Product / Process Change Notification (PCN)

PCN #: PCN_UtMID_20200720

Affected Series: UtMID

DETAIL OF CHANGE:

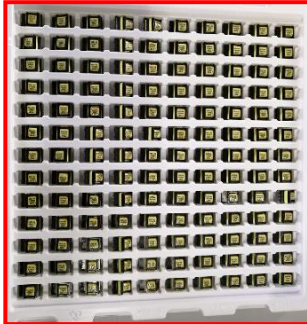
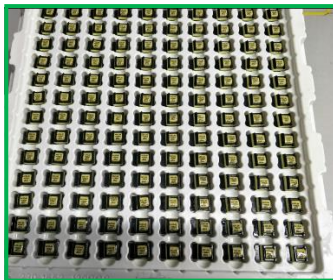
For improved transportation safety, Würth Elektronik will change the form of the shipping tray pocket and will add a piece of cardboard between each tray for the following part numbers:

There will be no change to the number of parts per tray and there will also be no change in form, fit, function or reliability of the product.
